# PlanGrid Task Report - Jun 13, 2024

3 tasks in this report.

# #593 [UNIT 999][EXIST] (MISC) RTU-3 alarm

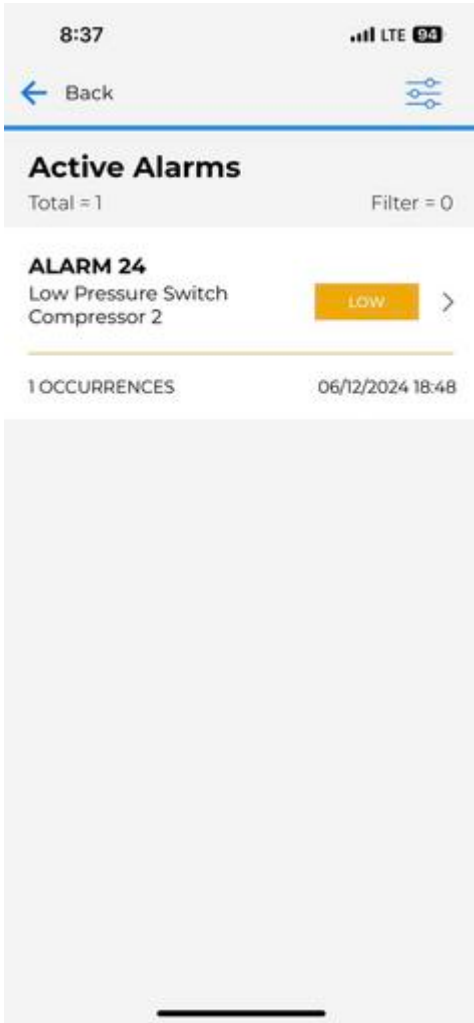
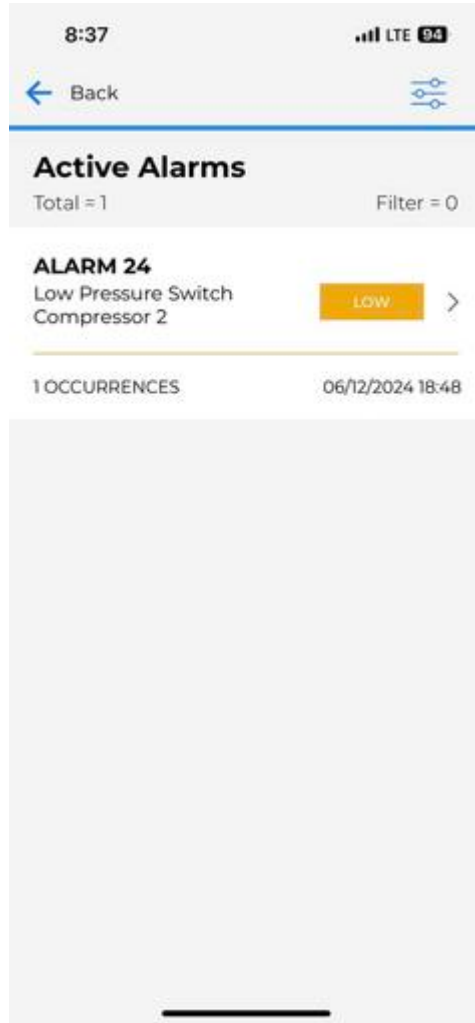
AC-3 has an active alarm. The alarm is (24) Compressor 2 low pressure switch. MC to evaluate and fix as required.

### #589 [CNTL 509][EXIST] ANSUL pull Labeling

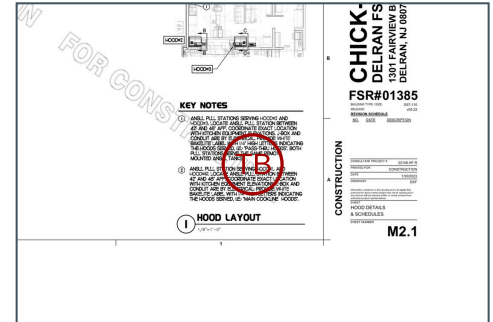
Label all ANSUL pull stations for which hood they serve per the spec

# #587 [EXHA 006][EXIST] Restroom fan speed controller

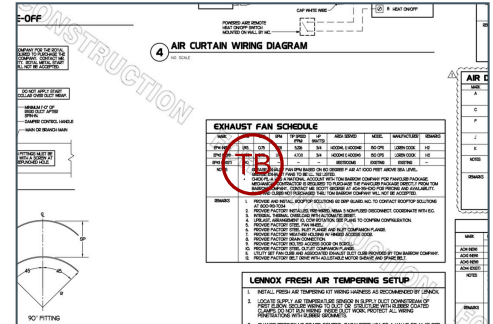
Existing EF-3 does not have a speed switch installed. Unable to accurately balance the system until corrected. Note: MC attempted to install a speed switch but the motor started to hum and get extremely hot very fast. Mc removed speed switch and rewired for low fan speed and system is in design airflow and TAB was completed. Recommend consulting CFA construction manager on next steps. Since system is balanced recommend at least installing a roof disconnect switch.
